**TOWN OF WOODSTOCK, NH
ROUTE 3 (N. STATION TO S. STATION) WATER MAIN REPLACEMENT**

ADDENDUM #1

July 13, 2026
Project: 250860

100' to 1" OVERLAY TRANSITION

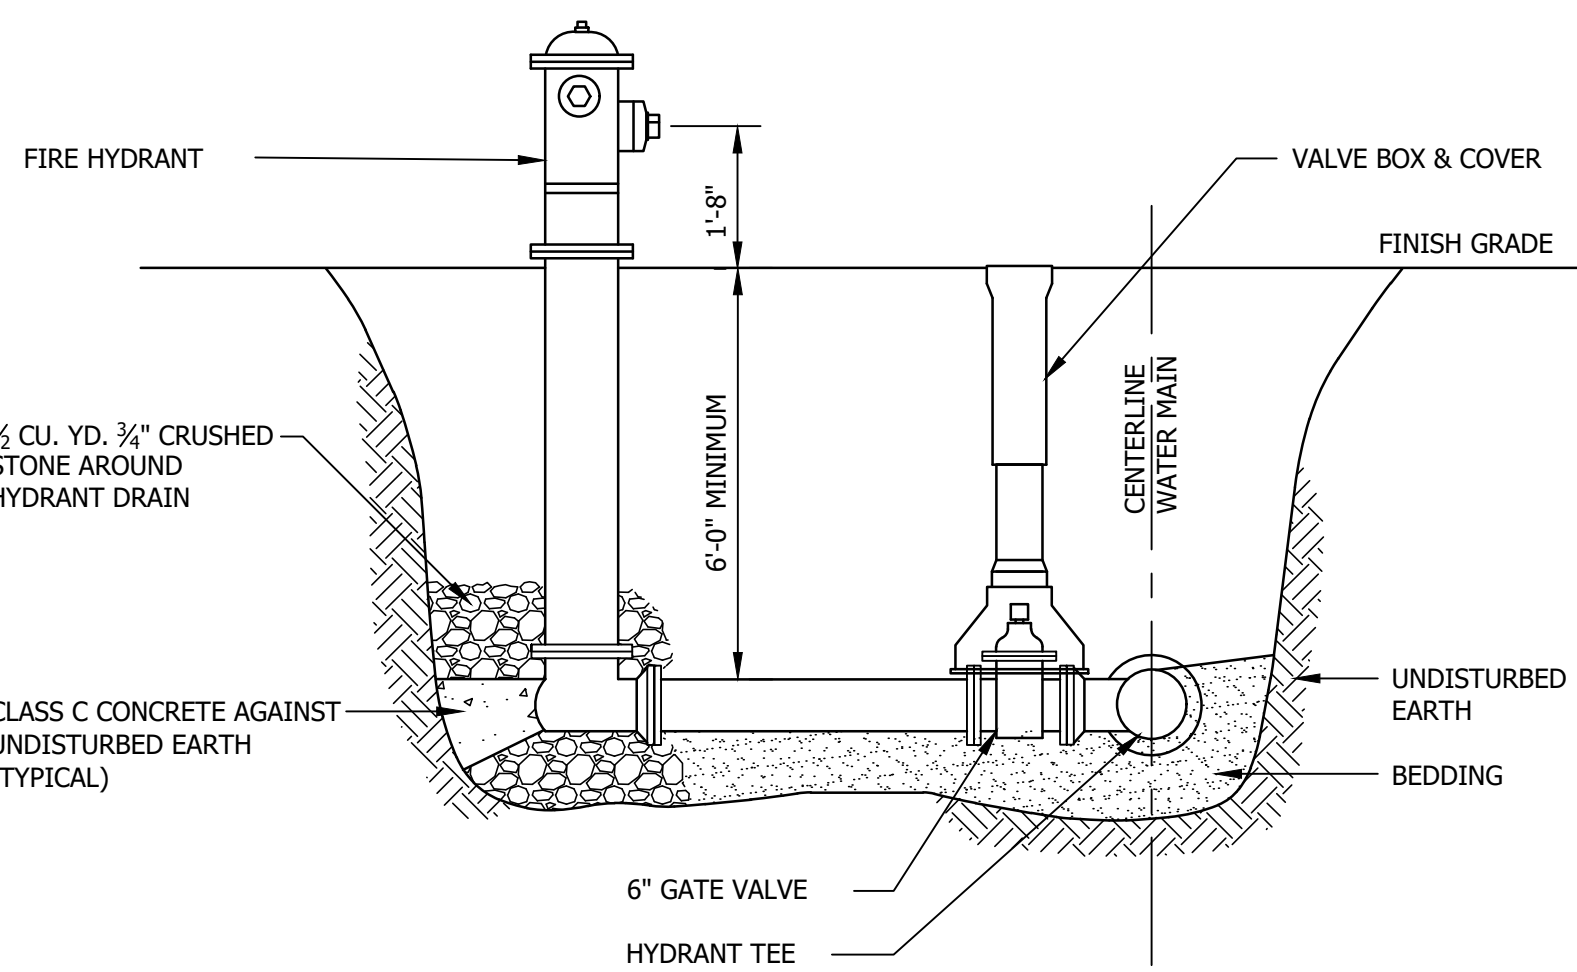
- 4) Is milling required for the full width 1" overlay? What are the overlay limits?

Response: *Full Pavement overlay is for Route 3, Station 0+25 to 9+20. Per NHDOT District 3, a 100' to 1" transition is required at the beginning and at the end of the paving limits. The transition shall be milled per overlay transition detail on sheet 4.*

NO.	DATE	REVISION DESCRIPTION	ENG	DWG
Δ	7/2026	ADDENDUM 1: REVISED TRANSITION DETAIL	MLB	JCH
